# OXFORDSHIRE COUNTY COUNCIL'S RESPONSE TO CONSULTATION ON THE FOLLOWING DEVELOPMENT PROPOSAL

**Application no:** 22/01340/OUT

**Proposal:** Application for outline planning permission (all matters reserved except means of access (not internal roads) from b4100) for the erection of buildings comprising logistics (use class b8) and ancillary offices (use class e(g)(i)) floorspace; energy centre, hgv parking, construction of new site access from the b4100; creation of internal roads and access routes; hard and soft landscaping; the construction of parking and servicing areas; substations and other associated infrastructure.

**Location:** East Of Baynards Green Farm Street To Horwell Farm Baynards Green

### **Public rights of way**

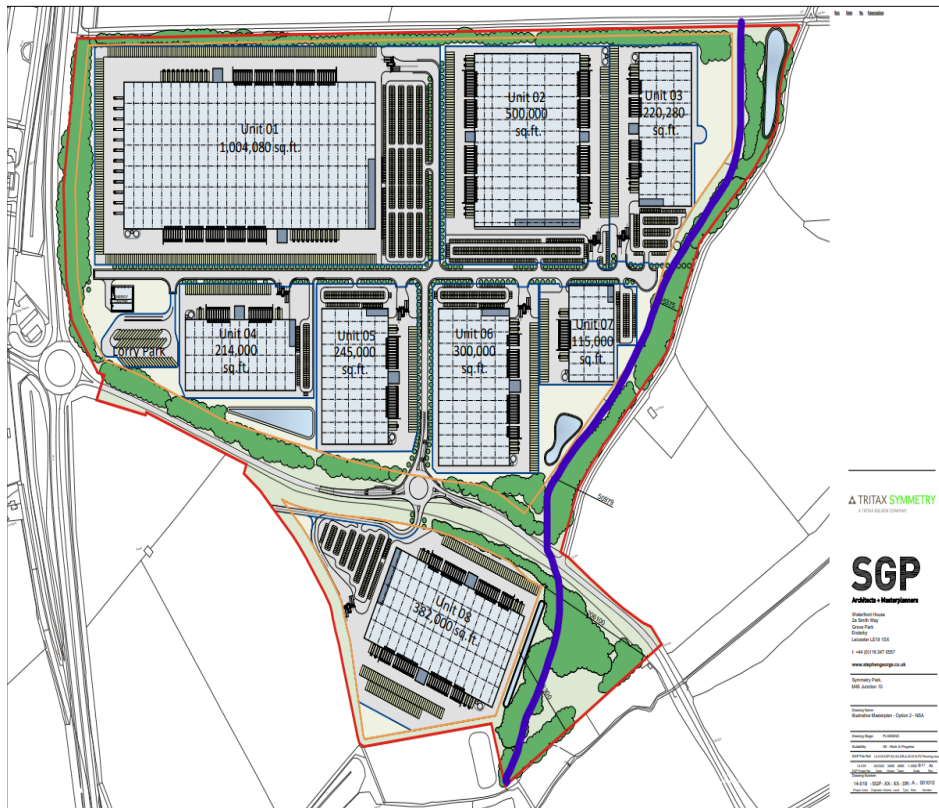
Connections should be made to the bridleway to the north of the site, to enable staff to use it to access the site and walk for recreation on their break. At the south of the site, connection should be made to Bridleway 21/10, in order to allow staff to access the facilities at the motorway service area.

The development is likely to have a an negative impact on the local road network which is used to link up many of the Public Rights of Ways, in particular for Bridleway users. Therefore I would like to see some additional access provided North to South through or along the edge of the site to link up bridleways 367/24/10 and 367/21/10, see suggestion below (blue line).
